**United Kingdom Holocaust Memorial
and Learning Centre**

Environmental Statement (Volume 5)
Appendix M Transport Assessment
Addendum
August 2019

2. TFL AND WCC COMMENTS

Figure 2 – Cycle Parking Design

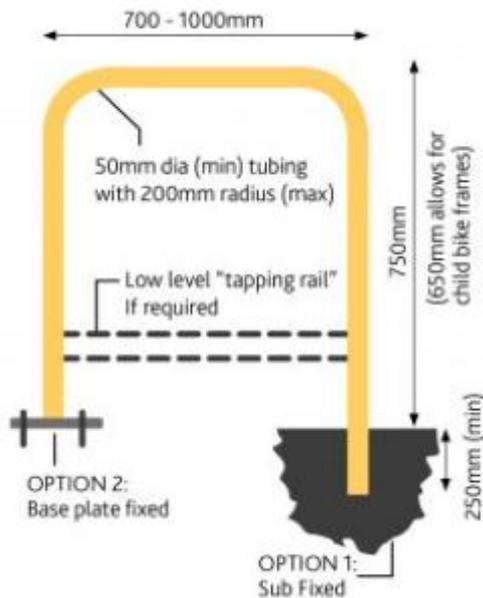
“The site does not contain cycle parking to accommodate visitors. The reasoning (constraints of the site) highlight overall problems with site to accommodate the proposal in highway and transport terms and impact on the surrounding highway and its users. Further, given the increased volumes of people in the area, locating the short term cycle parking on highway will create additional obstructions to pedestrians. The location of short term cycle parking needs to be reviewed.”

- 3.3.7. Figure 2 illustrates two options for cycle parking stands, option 1 which uses a fixed base plate at ground level with minimal drilling beneath the surface, and option 2 which involves intrusion into the ground for a sub-fixed cycle stand would require excavation of a minimum of 250mm.
-

- 3.3.8. Whilst the depth of buried utilities is yet to be established is considered that there is likely to be space along the footway to accommodate an additional 17 Sheffield stands. This may involve placing them at different locations along the same section of footway at locations where no buried services are present.

Figure 9 - Millbank Healthy Streets audit results

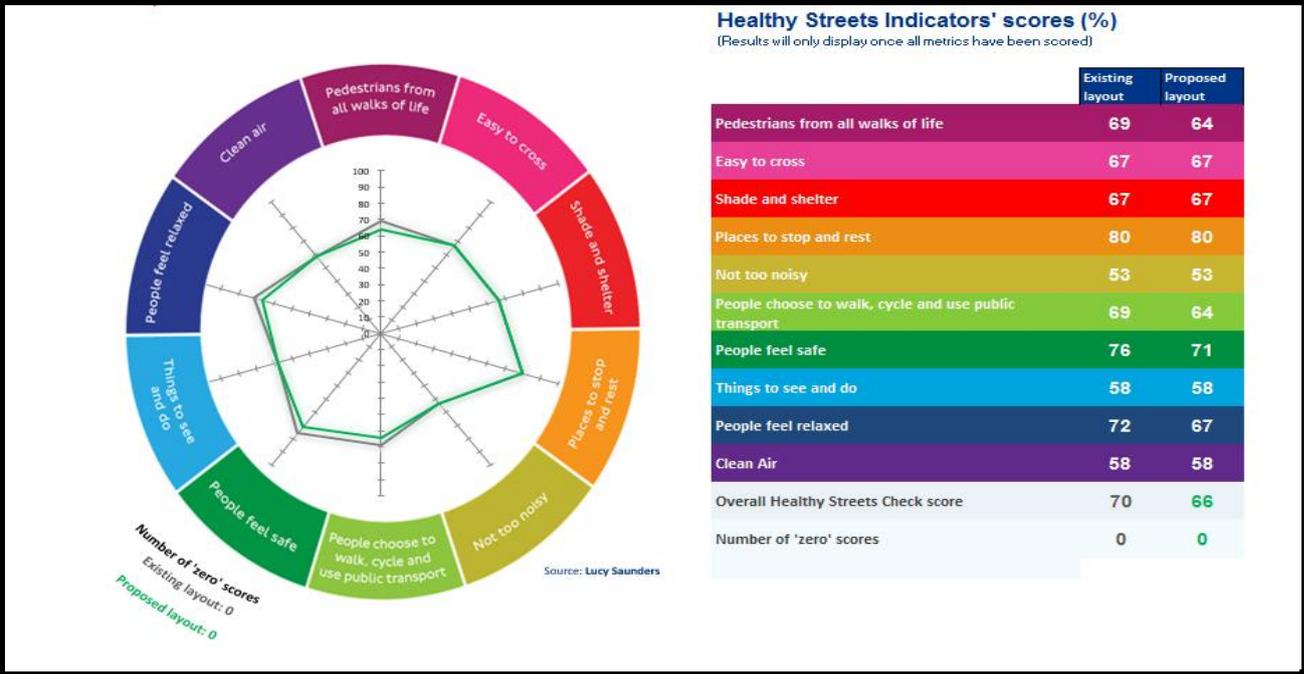
“The adverse impacts of the proposals are highlighted in the applicants own assessment against the Healthy Street criteria – with a reduction of 5 points and the addition of a zero score – when compared to the existing highway environment. The applicant is offering no alternative design, management or mitigation to address this. This aspect needs to be reviewed.”

- 5.2.3. The Healthy Streets audit for the Millbank baseline arrangement received a score of 70%, scoring well on crossing facilities, effective footway widths, quality of walking surfaces, lighting, surveillance and street trees. No metrics received 'zero' scores.
- 5.2.4. The Healthy Streets audit for the proposed Millbank interface arrangement received a score of 66% with no metrics perceived to merit a "zero" score.
- 5.2.5. As outlined above the scheme does not significantly alter the Millbank interface except for the eastern kerbside design to facilitate coach drop-off and pick-up without reducing bus stop capacity for TfL buses.
- 5.2.6. Figure 9 below shows the Healthy Streets audit results for the section of Millbank affected by the proposed development.

- 5.2.7. It is concluded that the Millbank interface scores well in both the existing and proposed scenarios when assessed using the Healthy Streets Audit. The proposals do not significantly alter how pedestrians interact with Millbank and the existing infrastructure creates a healthy environment for all users.
- 5.2.8. As highlighted by Figure 9, the proposed scheme results in a slight reduction in the Healthy Streets score following alterations to the existing bus and general traffic lane on the eastern side of the carriageway adjacent to the site. This has a minor effect on cyclists using Millbank; however, this is not expected to significantly impact existing cyclists using the route.
- 5.2.9. The full Healthy Streets Audit report is provided in Appendix B.
